From: Pederson Ronda M (AREVA NP INC) [Ronda.Pederson@areva.com]
Sent: Wednesday, September 24, 2008 5:53 PM
To: Getachew Tesfaye
Cc: WELLS Russell D (AREVA NP INC); John Rycyna; DELANO Karen V (AREVA NP INC); BENNETT Kathy A (OFR) (AREVA NP INC)
Subject: Response to U.S. EPR Design Certification Application RAI No. 29, Supplement 1
Attachments: RAI 29 Supplement 1 Response US EPR DC.pdf

Request for Additional Information No. 29 Supplement 1, Revision 0

U. S. EPR Standard Design Certification

SRP Section: 15.04.02 - Uncontrolled Control Rod Assembly Withdrawal at Power

Figure 15.4-54—Uncontrolled Control Bank Withdrawal at Power - Representative Plot of Normalized Minimum DNBR and Maximum LPD to SAFDL

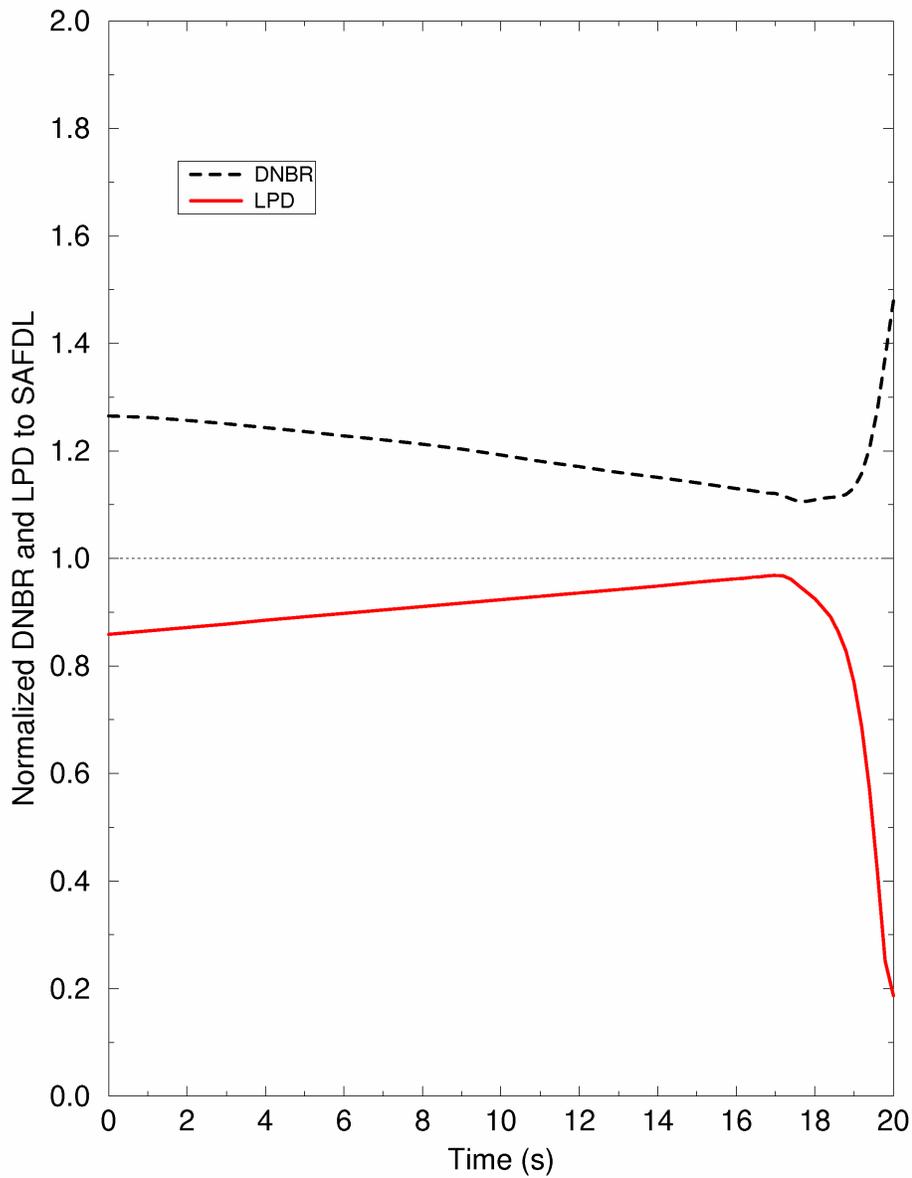
Please provide plots of DNBR and peak fuel centerline temperature as a function of time during this event to demonstrate that these limits are met.

A representative plot of the minimum departure from nucleate boiling ratio (DNBR) and maximum linear power density (LPD), normalized to their respective specified acceptable fuel design limits (SAFDL), is shown on the attached new U.S. EPR FSAR, Tier 2, Figure 15.4-54—Uncontrolled Control Bank Withdrawal at Power – Representative Plot of Normalized Minimum DNBR and Maximum LPD to SAFDL. This event results in both low DNBR channel and high LPD channel incore trips.

The LPD line on the figure is the calculated linear power density normalized to either the fuel centerline melt or cladding strain limits (whichever is more limiting), including the applicable uncertainties. For anticipated operational occurrence (AOO) events, the SAFDL for cladding strain is more limiting and is therefore used to provide the normalized LPD. The LPD SAFDL is designed to protect both the fuel centerline melt and cladding strain limits, as discussed in ANP-10287P, Revision 0, "Incore Trip Setpoint and Transient Methodology for the U.S. EPR Topical Report."

The DNB reactor trip (RT) and high LPD RT setpoints, as well as the dynamic compensation built into the low DNB channel algorithm and the high LPD channel algorithm, are adequate to protect the SAFDL for the conditions that cause the low DNB channel or high LPD channel to issue an RT signal. For conditions where the DNB and LPD degradation do not cause an RT, both the DNB limiting condition for operation (LCO) and the LPD LCO are adequate to protect the SAFDL. This demonstrates that both the fuel cladding integrity is maintained and the peak centerline temperatures remain below the fuel centerline melt limit.

Figure 15.4-54—Uncontrolled Control Bank Withdrawal at Power - Representative Plot of Normalized Minimum DNBR and Maximum LPD to SAFDL presents a representative case of DNB and LPD normalized to their respective SAFDLs.
